# UNITED STATES PATENT AND TRADEMARK OFFICE

APPLICATION NO.	FILING DATE	FIRST NAMED INVENTOR	ATTORNEY DOCKET NO.	CONFIRMATION NO.
09/901,576	07/11/2001	Kazuo Saito	K&Y-157-114	7170

<b>Office Action Summary</b>	Application No.	Applicant(s)	
	09/901,576	SAITO ET AL.	
	Examiner	Art Unit	
	Raymond Alejandro	1745

## **DETAILED ACTION**

As illustrated in **Figures 1 and 7** below, the separator comprises a base material in the form of a flat plate having a plurality of grooves at one or both sides thereof.

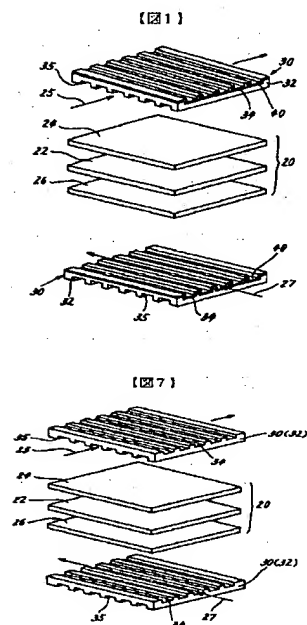
The JP'062 publication discloses a separator for solid electrolyte fuel cells wherein the separator has a surface protective layer containing conductive ceramic powder and glass on the

surface of the separator base material (ABSTRACT). *It is noted that, in this case, the glass itself acts as a binder material, that is, the glass produces or promotes cohesion in loosely mixed substance/powder of the conductive powder.* It is also disclosed that the thickness of the film ranges between 10-100  $\mu\text{m}$ , preferably, 10-50  $\mu\text{m}$  (SECTION 0012).
